MIL "ON" DTC P0401 and/or Rattle After Cold Soak

SUPERSESSON NOTICE

The information contained in this bulletin supersedes SB No. T-SB-0075-13.

Some Prius, Prius V and Prius PHV vehicles may exhibit a vibration due to rough idle and/or tapping noise from the HV transaxle at cold start. The Check Engine Light may also illuminate with (DTC) P0401 (Exhaust Gas Recirculation Flow Insufficient Detected). Due to excess carbon build up at the valve assembly, the valve will stick causing the engine RPM to fluctuate. Follow the procedures in this bulletin to address this condition.

Figure 3.

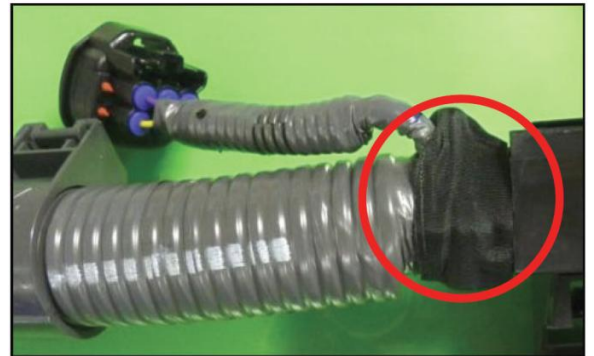
C. Wrap the exposed zip tie 7 – 8 times with heat resistant vinyl tape.

Figure 4. Location of Authorized Modifications Label for 2010 - 2012 Prius and 2010, 2012 Prius PHV

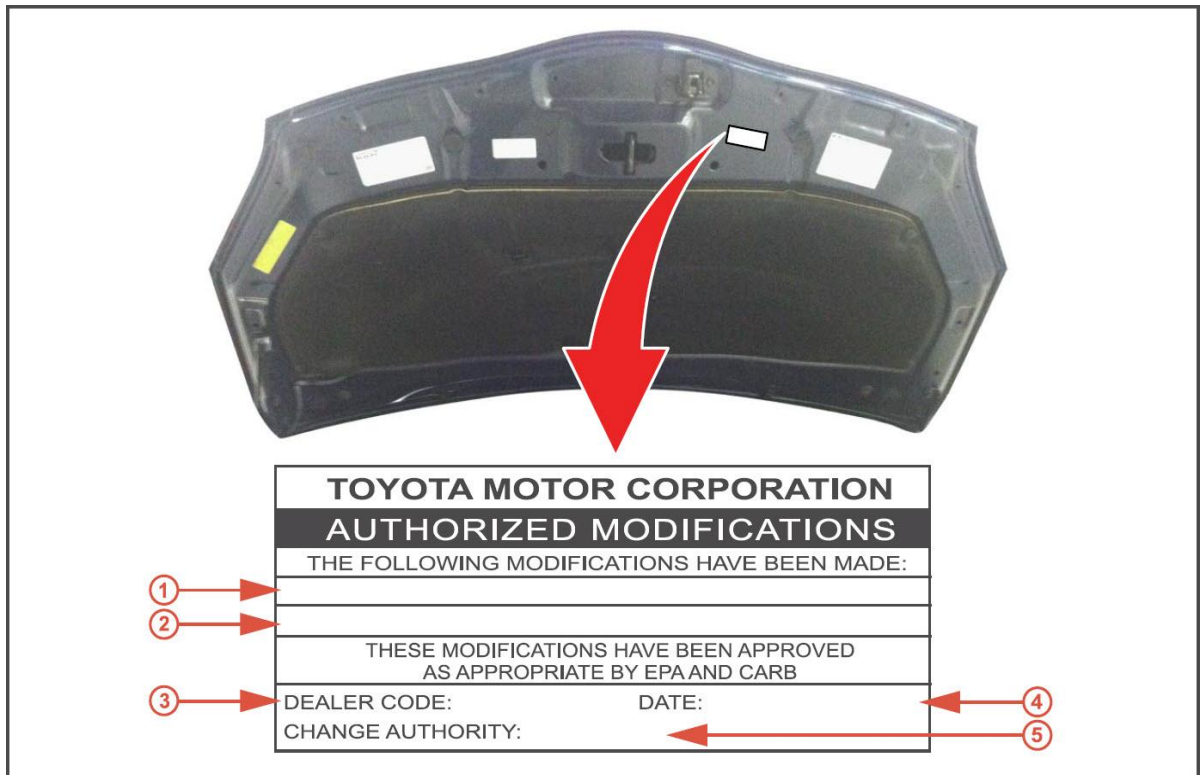
4. Check for the Authorized Modifications Label affixed to the vehicle in the location shown in Figure 4 below. Confirm if the ECM (PCM) calibration has been updated. If the calibration ID listed is NOT the latest ECM (PCM) calibration — go to step 5. If the calibration ID is the latest, go to step 7.

Figure 5. Location of Authorized Modifications Label for 2012 Prius V

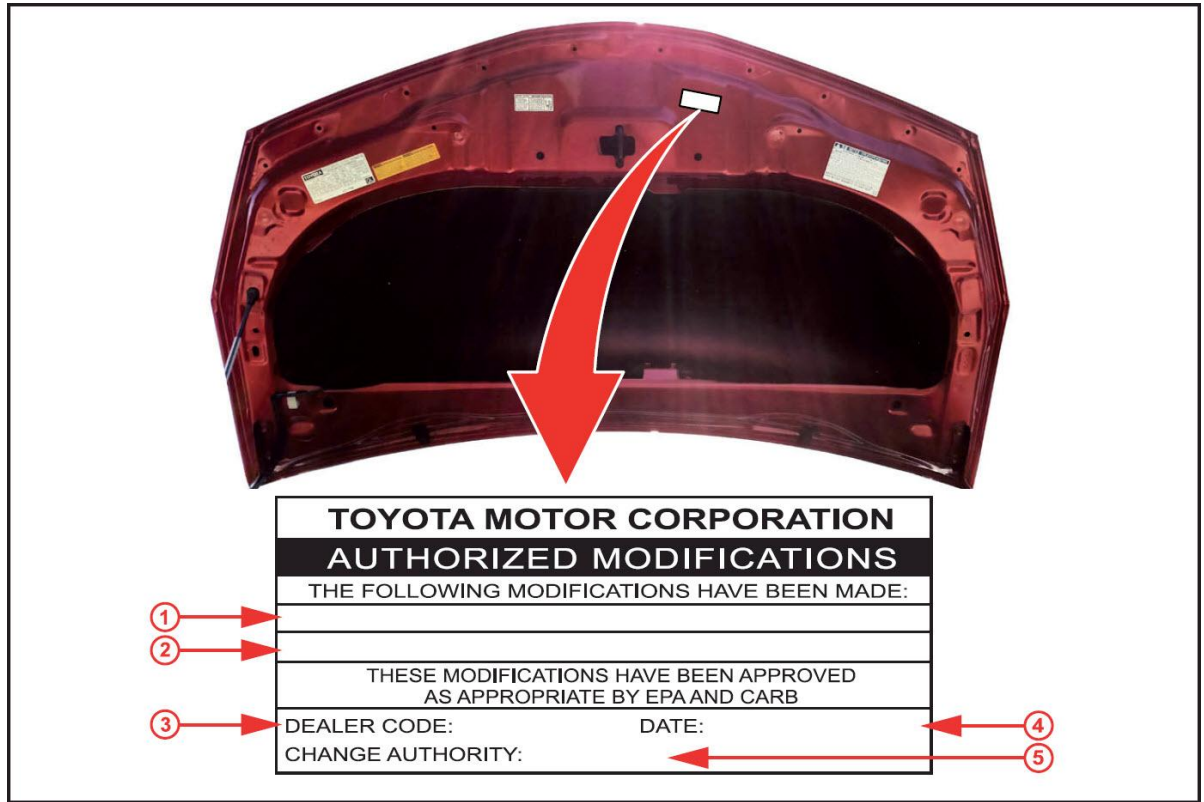
6. Install the Authorized Modifications Label.
 - A. Using a permanent marker, enter the following information on the label:
 - ECM part number [*Refer to the **Parts Information** section for the **NEW PART NUMBER***]
 - Calibration ID(s) [*Refer to the **Calibration Information** section for the **NEW CALIBRATION***]
 - Dealer Code
 - Repair Date
 - Change Authority [**This bulletin number**]
 - B. Affix the Authorized Modifications Label to the vehicle at the location shown in Figures 4 and 5. The Authorized Modifications Label is available through the MDC, P/N 00451-00001-LBL.
7. Confirm the repair.
